Your ref: SSD91539707

MIXED USE DEVELOPMENT AT 19A 21 GORDON STREET, COFFS HARBOUR - SSD91539707

I refer to the above-mentioned application and request for comments from the City of Coffs Harbour Council (City).

Figure 1. 1% AEP flood level and flood planning level across the site

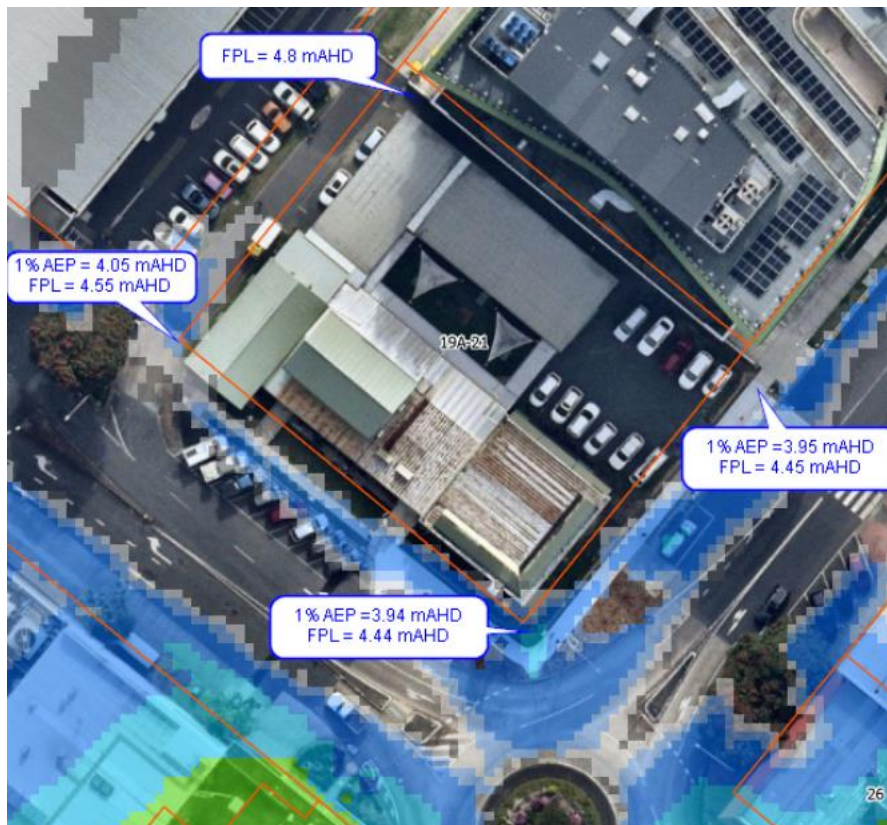
The plans and flood assessment report indicate proposed finished floor levels of 4.15 mAHD for the ground floor retail areas on the corner of Gordon and Vernon streets, and 4.3 mAHD along Riding Lane, Vernon Street closest to Riding Lane, and Gordon Street closest to Yarrila Place. The finished floor level for the place of worship is 4.3 mAHD. All car parking and residential habitable areas are above 8.8 mAHD, with the residential lobby at 4.3 mAHD.

The flood information from the Coffs Creek Floodplain Risk Management Study (WMAwater, 2025) indicates a flood planning level (1% AEP plus 500mm freeboard) that varies from 4.44 mAHd (corner of Gordon and Vernon St) to 4.8 mAHd (Riding lane closest to Yarrila Place). The flood planning level at the centre of the lot is 4.59 mAHd. See figure 1 for details of the nearby 1% AEP flood level and flood planning level.

The proposed floor levels provide less than the required 500 mm freeboard to the nearest 1% AEP flood level for commercial development under Part E4.4 of the DCP. The flood assessment report seeks to justify this by adopting the superseded flood planning level of 4.3 mAHd, incorporating flood-compatible building measures below that superseded flood planning level, and indicating that the current flood planning level would impose undesirable constraints on the public domain. This is not considered an adequate justification.

The City would only support a reduction in freeboard to the current 1% AEP flood level provided adequate justification is provided taking into account adjoining land uses and floor level, flood levels, access constraints, fill requirements and the existing development.

4.6 Site Plans

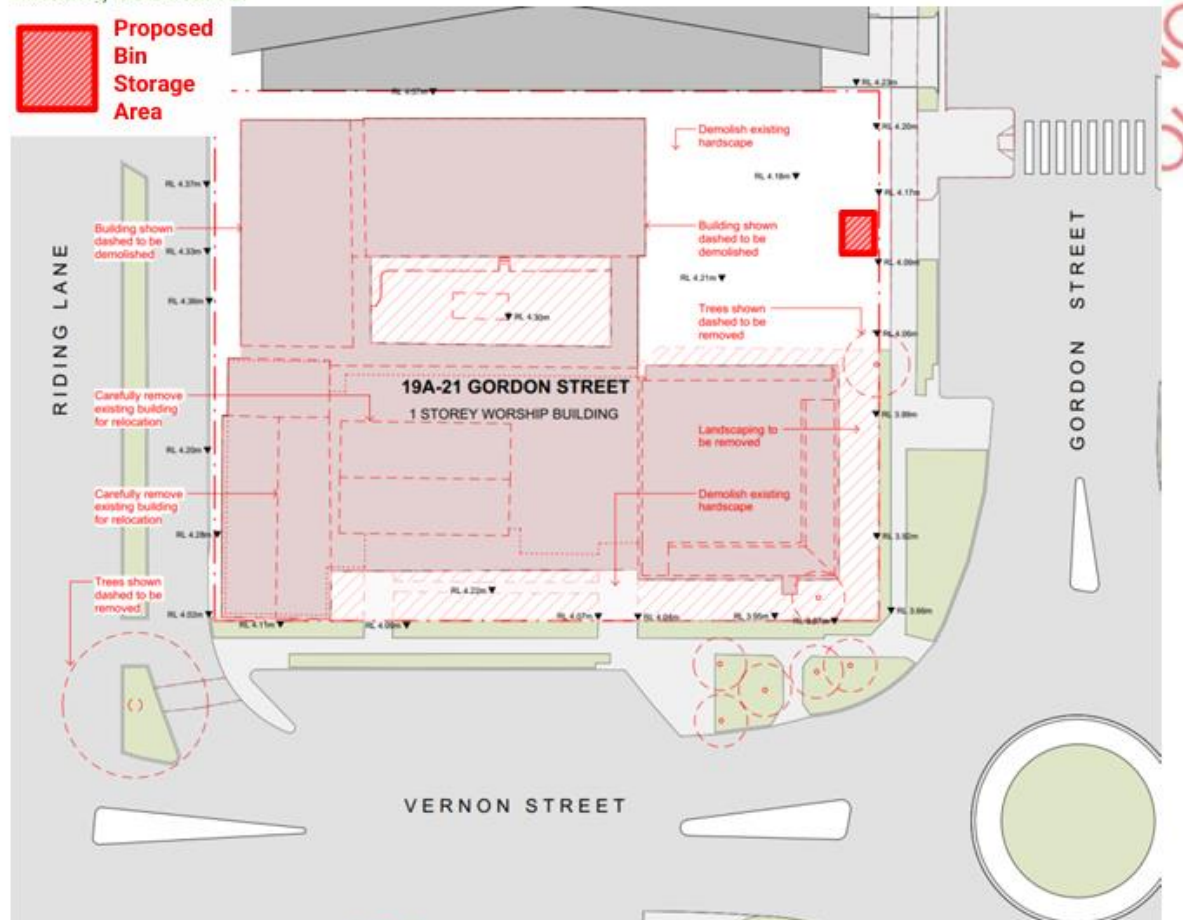
Note: the proposed bin location is indicative only, this may change based on site logistics.
